REMARKS

The amendments to this Patent Application are as follows. An Abstract Of The Disclosure has been added on its own separate page. The Specification has been amended on pages 1, 2, 3, 4, 5, 6, 7, 8, 9, 10, 11, 12 and 16 to include the required section headings and to eliminate reference to the claims. On Page 1 a Cross-Reference To Related Patent Applications has been inserted. On Page 12, a brief description of FIG. 7 has been added. A new revised sheet of drawings for FIGS. 30 and 31 is attached hereto. A Marked-Up Copy of drawings is also enclosed.

The present divisional patent application is being filed for these nonelected embodiments according to the originally filed FIGS. 18 and 19, which correspond to species H and I which in turn correspond to previously filed claims 60 and 61.

Fig.30**Fig.31**

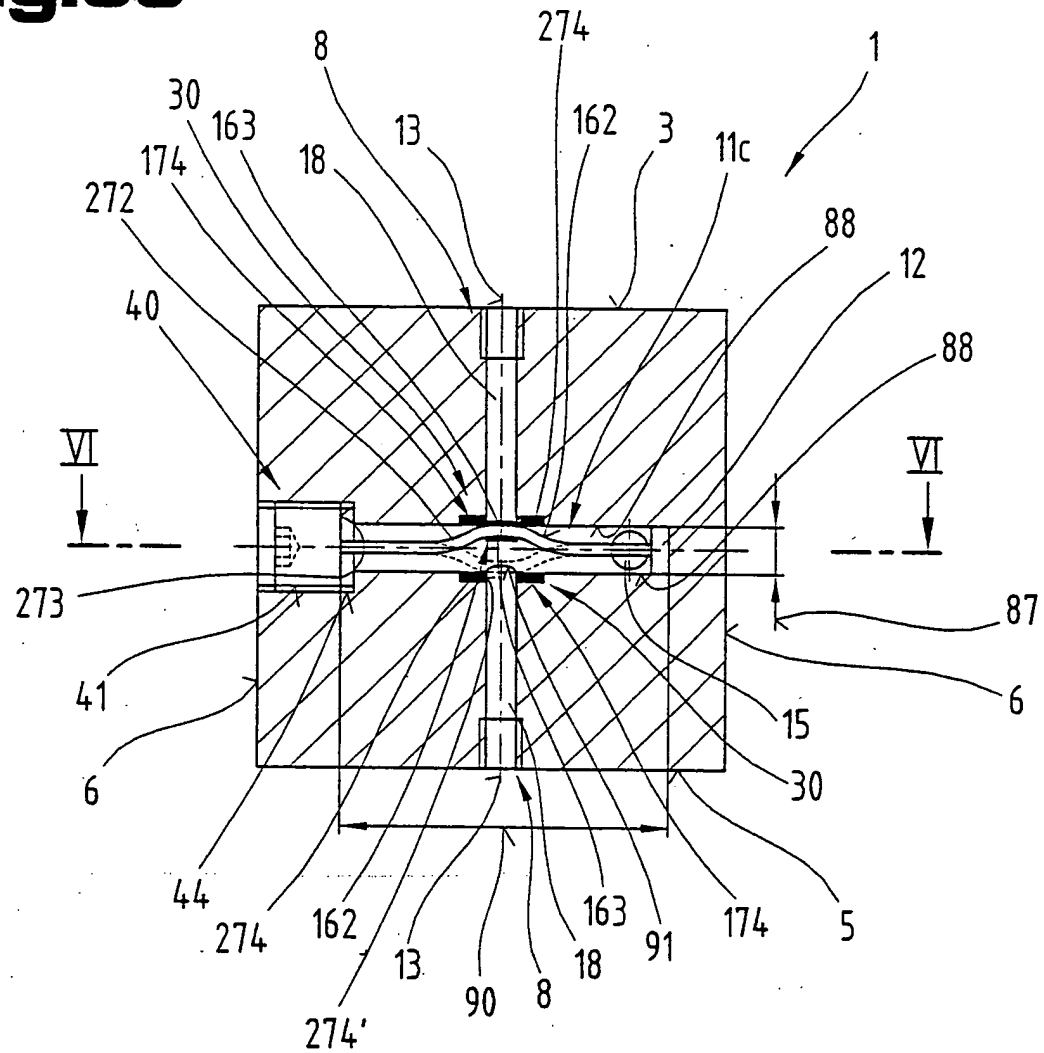
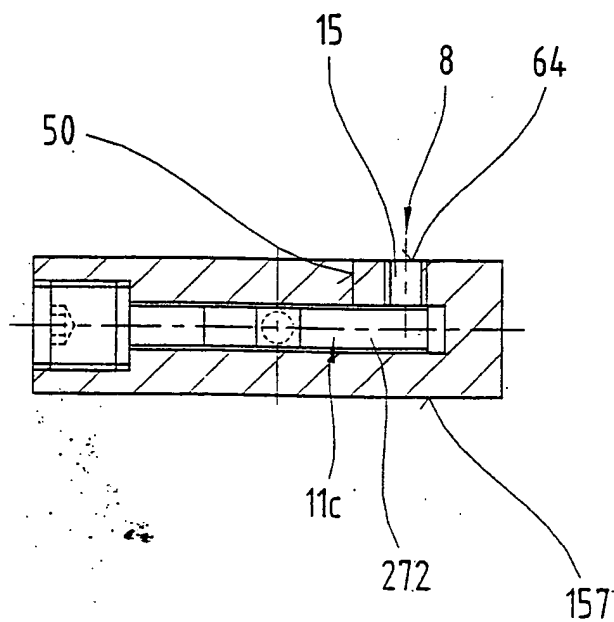
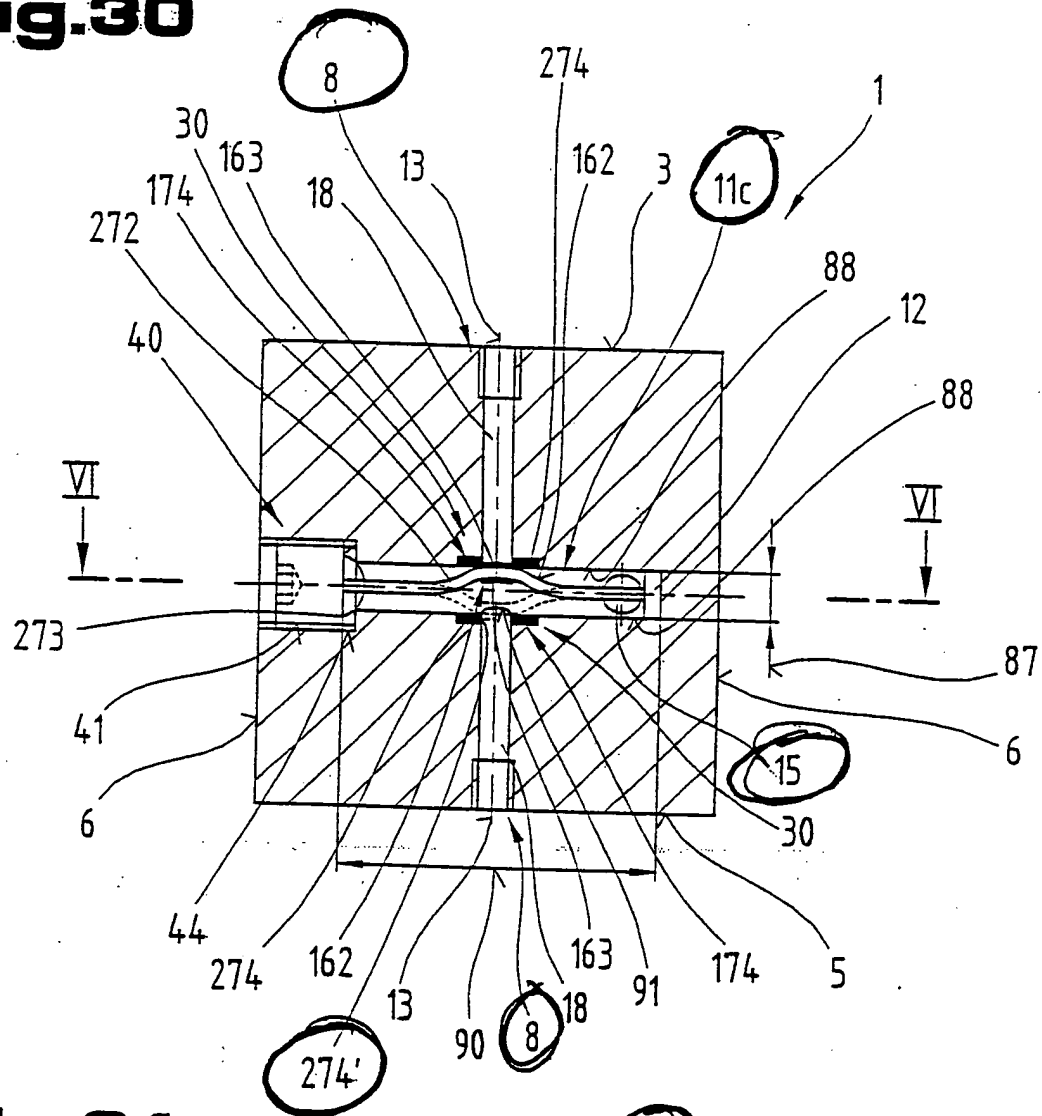
After reviewing FIG. 30 it was noticed that the channel (8) shown in FIG. 31, in particular the flow-through channel (15) is not shown in FIG. 30. Therefore enclosed herewith is a corrected FIG. 30 showing this flow-through channel (15). Also added is the missing reference symbol 274' denoting the opening in the flat coil 274, and reference numeral 163 denoting the sealing layer on the underside of the membrane 272.
